### ***NOISE ADDENDUM – WHITECHAPEL ROAD, CLECKHEATON***

SLR Consulting Ltd. has been appointed to prepare a Noise `Addendum Letter, in relation to a residential development, located off Whitechapel Road, Cleckheaton.

This Addendum Letter presents the updated glazing and ventilation scheme, following amendments to the housing layout at the development site.

**Figure 1**  
**Location of 2.1m High Barrier (Looking Down the Embankment)**

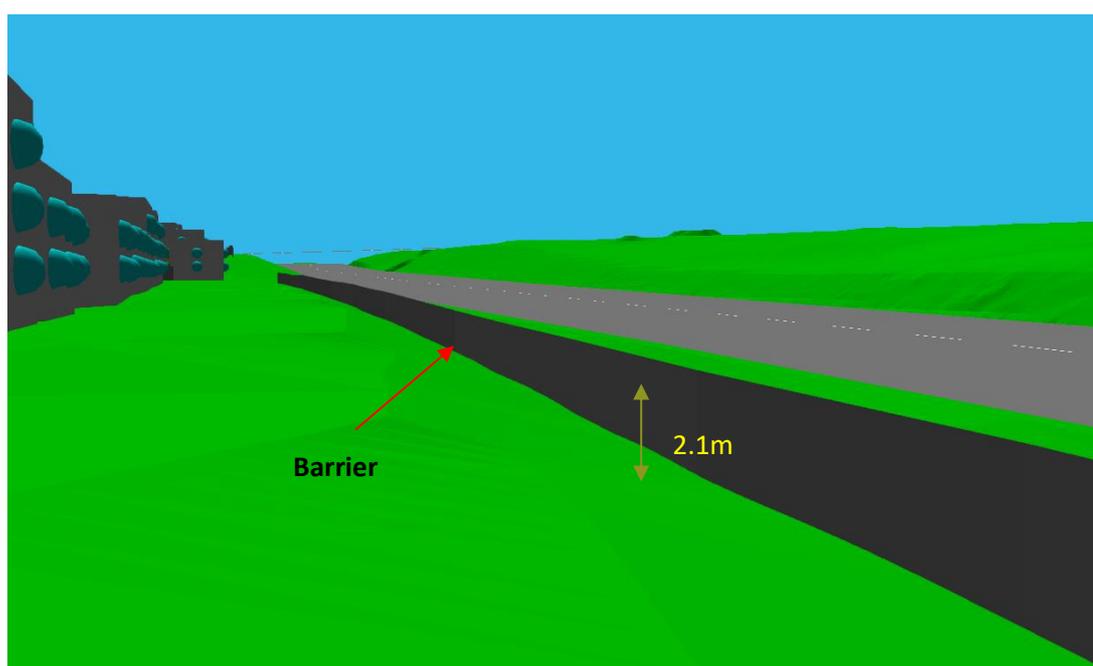
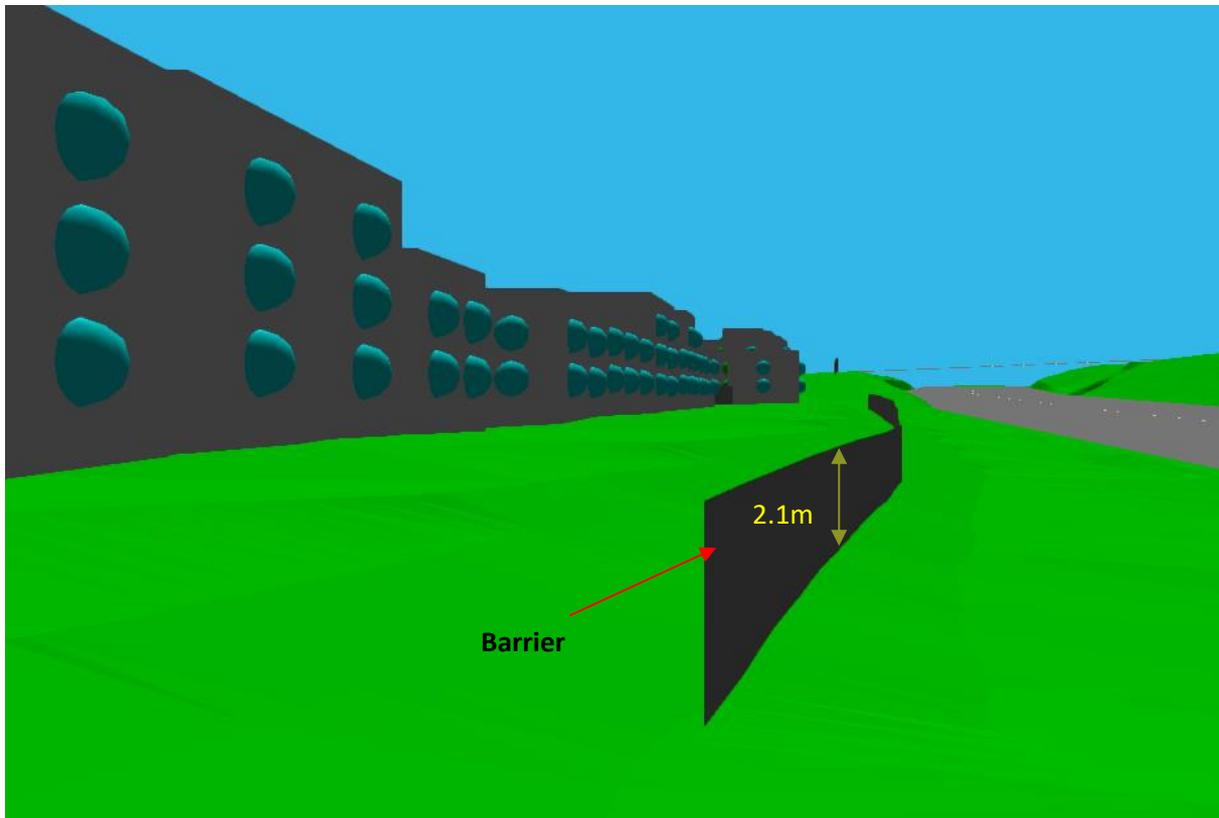
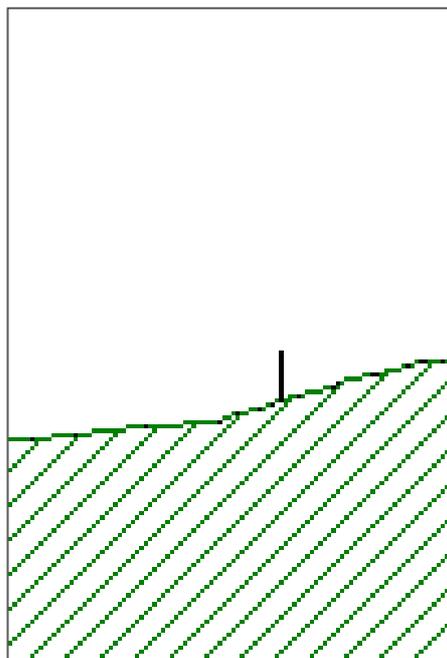
Since submitting Version 1 of this letter, it is understood that the Council has queried the removal of a 1m high bund that was included on drawing number H8040-TL 01F and have asked for confirmation that the removal of the bund will not affect the noise environment at the Site.

Whilst this bund was included on drawing number H8040-TL 01F it was removed from the noise assessment completed in 2021 (and subsequently updated in this Addendum) as a precaution because it was understood that the bund may hinder formation of the footpath. A screenshot of how the 2.1m high barrier appears in the noise model is shown in Figures 1 to 3.
